Access Compliance Report

Public Rights-of-Way

Intersection ID: 51071	Main Street: KEMPSFORD_DR	Cross Street: GRICKLADE_DR	Location: NW
ADA ID: 4CB8D2BEEB6C	Ramp Type: PerpDiag	Initial Pass/Fail: Fail	Overall Compliance: No
		Severity Score: 12.5

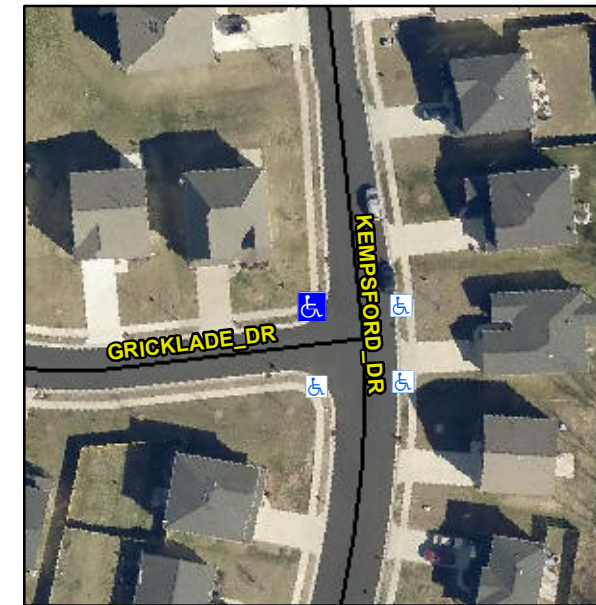
Not Found, R304.5.3

Compliance	Description	Data	Compliance	Description	Data
N/A	Ramp Length (in)	47.0	Yes	Ramp Slope (%)	8.1
Yes	Ramp Width (in)	48.0	No	Ramp XSlope (%)	5.9
N/A	Flare Type LT	N/A	N/A	Flare Type RT	N/A
N/A	Flare Slope LT (%)	N/A	N/A	Flare Slope RT (%)	N/A
N/A	Flare Traversable LT?	N/A	N/A	Flare Traversable RT?	N/A
N/A	Landing Length (in)	N/A	N/A	DWS Provided?	N/A
N/A	Landing Width (in)	N/A	N/A	DWS Contrast?	N/A
N/A	Landing Slope (%)	N/A	N/A	DWS Length (in)	N/A
N/A	Landing X Slope (%)	N/A	N/A	DWS Full Width?	N/A
N/A	Landing Curb? (Y/N)	N/A	N/A	DWS Offset (in)	N/A
N/A	Shared Landing?	N/A			
N/A	Gutter Ponding?	N/A	N/A	Gutter Slope (%)	N/A
N/A	Gutter Lip Ht (in)	N/A	N/A	Gutter X Slope (%)	N/A
N/A	Painted X Walk1?	No	N/A	Painted X Walk2?	No
	X Walk 1 Direction	To S		X Walk 2 Direction	To E
N/A	X Walk 1 Width (in)	N/A	N/A	X Walk 2 Width (in)	N/A
	X Walk 1 Slope (%)	2.2		X Walk 2 Slope (%)	1.6
	X Walk 1 X Slope (%)	2.4		X Walk 2 X Slope (%)	2.4

Remove & Replace Curb Ramp With Two New Directional Ramps or Equivalent.
